Service Bulletin

No. : MZ08-001

Model: SA8260

Subject: QY61 is damaged, and FLD does not turn on.

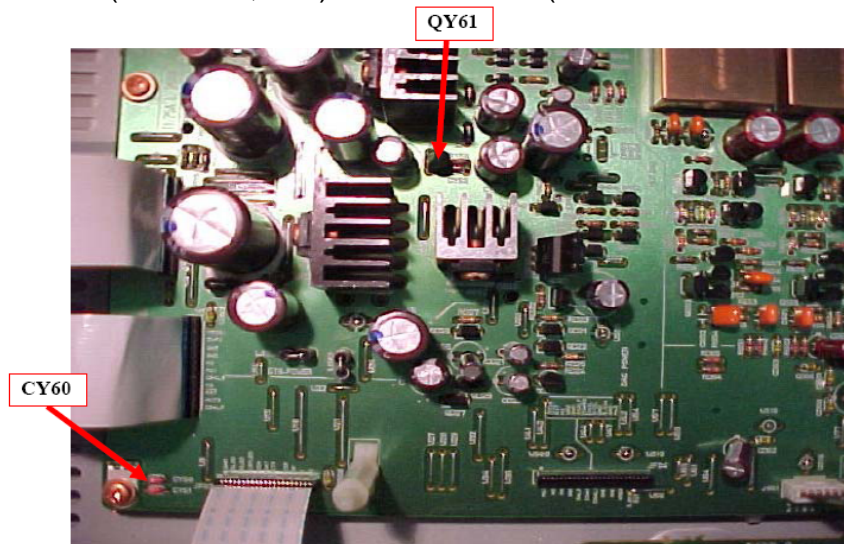
Symptom: QY61 may break down from an excess collector current generated by CY52 discharging electricity when the M1/M2-VF line and the GND short out. The short out can be caused at the time of production or servicing, or even when the power is off, by JF03 being improperly pulled out or inserted at an angle or by the mechanical chassis hitting the front PCB. Long-term use in this condition will lead to a breakdown of QY62.

Solution: 1) When the unit is dismantled for the mechanism or the PWB to be replaced, please discharge CY52 of charged electricity by contacting a 220-ohm resistor with both ends of CY60 on PP16 (POWER/AUDIO L R CIRCUIT BOARD) for 2 seconds or more.

2) Replace QY61 (2SA1048, etc.) with 2SB1240 (00MHT212402A0: IC max, 3A).
